D/DRC Case

1811 Pickens Street

DESIGN/DEVELOPMENT REVIEW COMMISSION
DESIGN REVIEW DISTRICT
HISTORIC AGENDA
EVALUATION SHEET
Case # 1

NATURE OF REQUEST: Request Certificate of Design Approval for exterior changes

Staff photos of porch floor immediately after replacement

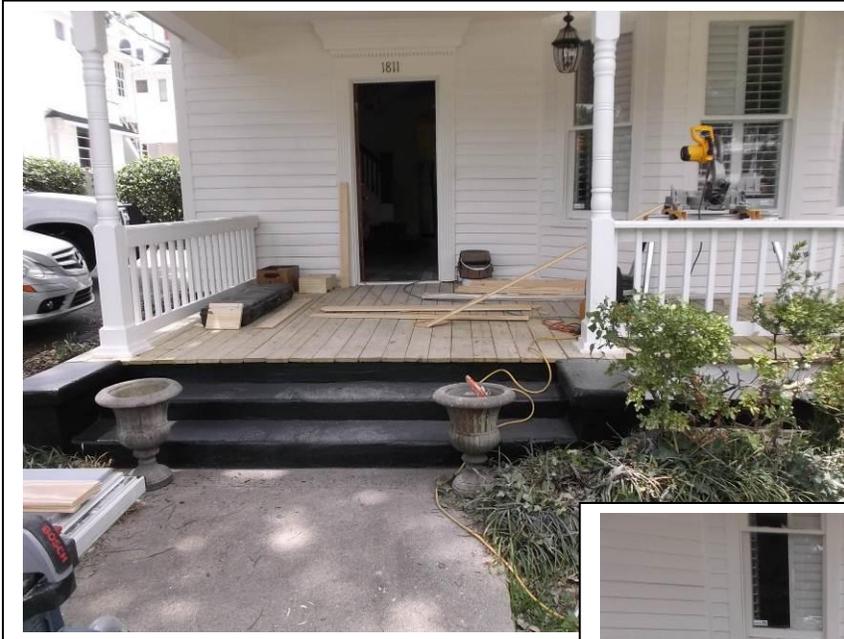
The owner stated that they were putting back what was on the porch floor, but Staff explained that regardless of what was on the porch most recently, when they do a complete removal of that material they must return to something in keeping with the historic materials and features that would have originally been on the building. Staff is unaware of the condition of the porch floor but historic porch floors are always tongue and groove wood, creating a seamless appearance.

There is no historic precedent for using deck boards as a front porch floor. Deck boards are for decks; they are marketed as such and are commonly understood to be for decks. Similarly, porch flooring is marketed as such and features the traditional tongue and groove interlocking edges, much like an interior wood floor. The sidewalk (public right of way) on this street is very close to the building so the porch floor is very evident as an alteration to the front of the house. The deck boards are much wider than traditional porch flooring and they have gaps between them.

While Staff does not know what was on the porch floor immediately preceding its recent wholesale replacement, it is another example where the complete loss of the original material should generate replacement with a new material that matches the old in “design, color, finish, texture and other visual qualities and, where possible, materials.” Wood porch flooring to match historic patterns is still widely available today, so it is possible to meet this ordinance with modern materials.

Staff recommends replacement of the porch floor with appropriate porch flooring within 60 days in order to comply with Section 17-674(d) of the City Ordinance. Appropriate porch flooring would be approximately 3 to 4 inches wide and 3/4 inch thick.

New door, installed without approval

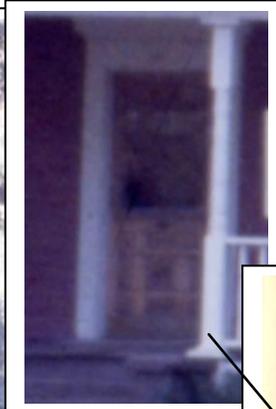
The door installed is not a typical front door design for a 1910s Folk Victorian style home nor does it replicate the original door; therefore it could be considered conjectural. In looking at two images from the early 1980s (one is included at the end of the evaluation, the other is on file at the State Archives), it is apparent that the door on the house at that time had a lattice work panel detail on the bottom half with a rectangular piece of glass on the top half. Staff has located this same door in a catalog from 1910, which is close to the latest possible construction date of 1913 for this building.

In looking at several door catalogues from the 1910s it is apparent that none of the doors featured an arch top nor did they feature muntins in the glass. Rear doors sometimes had muntins, but not the front doors. Patterns within this district and in other houses from the 1910s reveals that local patterns followed the same trends as those found in the catalogues;

glass was rectangular with no muntins. The door that has been installed is a change that is not in keeping with this guideline.

The door is a distinctive feature that had previously been missing from the home. The c. 1980s door that was in the house was clearly not original. When that door was removed, replacement by a new door appears to require a door that matches in “design, color, finish, texture” etc. to meet this ordinance. If the Colonial door had not been removed then there would have been no review needed as there would have been no exterior change. The new door fails to match the original door, which appears to be intact in early 1980s images. The new door has an arched glass inset with muntins; both the arch shape and the muntins are not typical of doors of the era and the door in general does not meet this ordinance as it does not match the old design.

Staff recommends removal of the new door within 60 days, with a replacement door to match the original in order to meet Section 17-674(d) of the City Ordinance, or they may reinstall the recently removed Colonial door. If they reinstall the Colonial door then there is no exterior change to review.
